ISO/IEC 11801-1:2017/Cor 1:2018

Information technology — Generic cabling for customer premises — Part 1: General requirements

ДСТУ ISO/IEC 11801-1:2018/Поправка № 1:2018
(ISO/IEC 11801-1:2017/Cor 1:2018, IDT)

C O R R I G E N D U M 1

Figure 1 – Relationships between the generic cabling documents produced by ISO/IEC JTC 1/SC 25

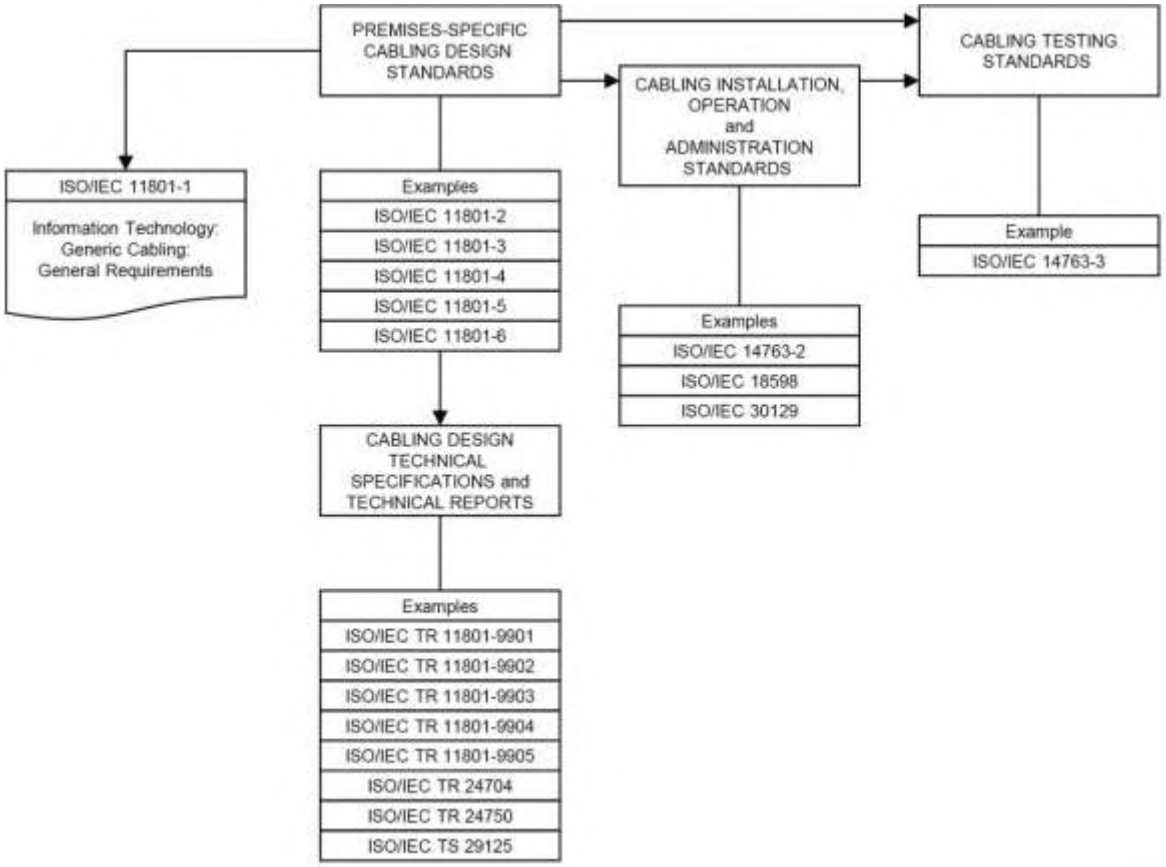
Replace the figure graphic with the following new figure graphic:

Figure 5 – Equipment and test interfaces

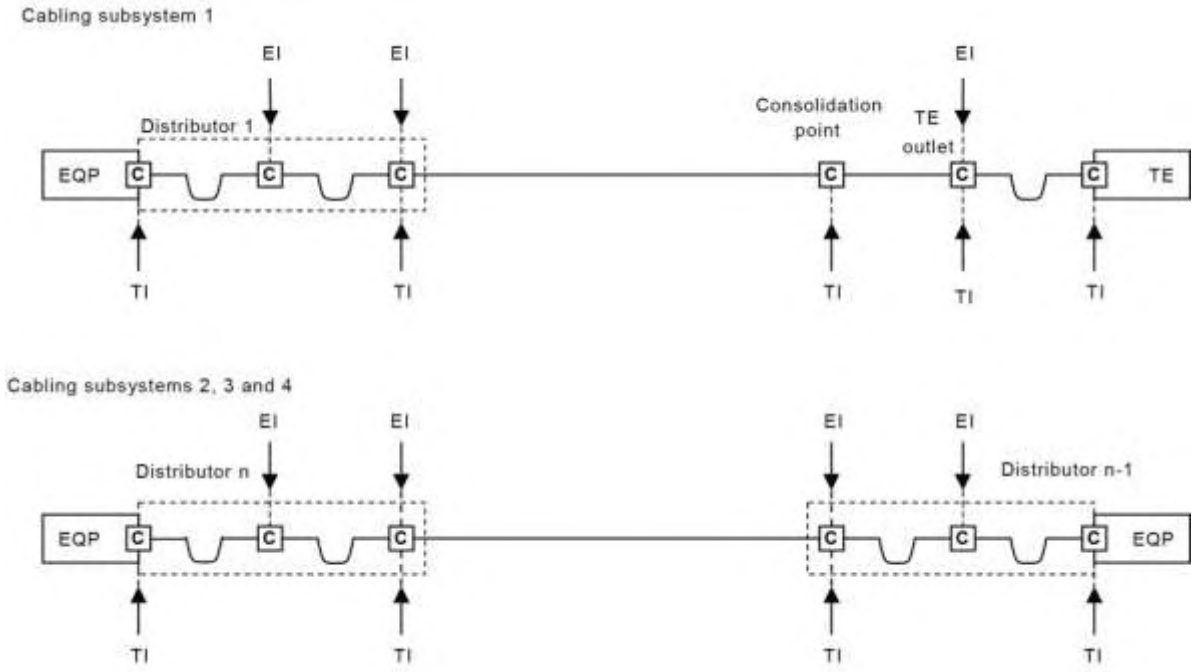
Replace the figure graphic with the following new figure graphic:

Figure 7 – Link designations

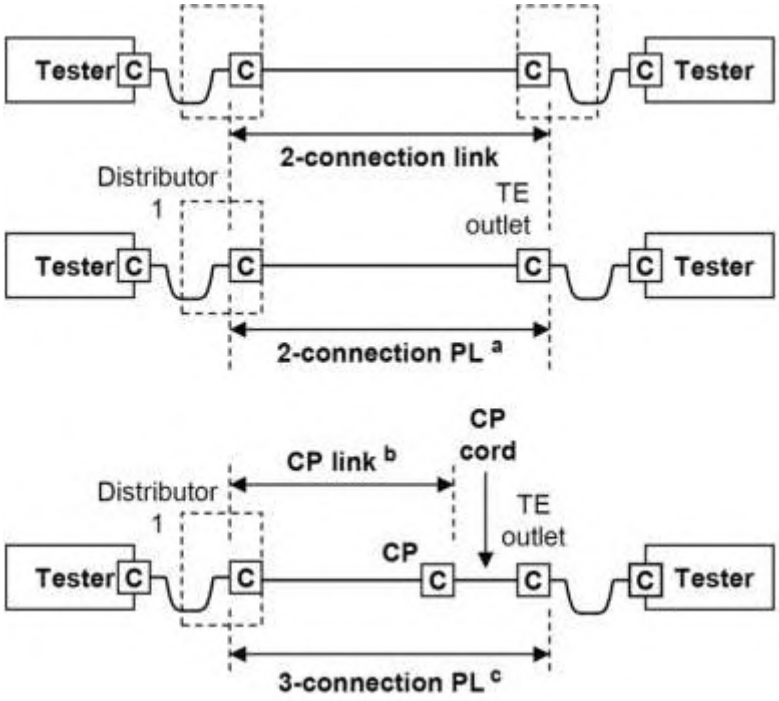
Replace the figure graphic with the following new figure graphic:
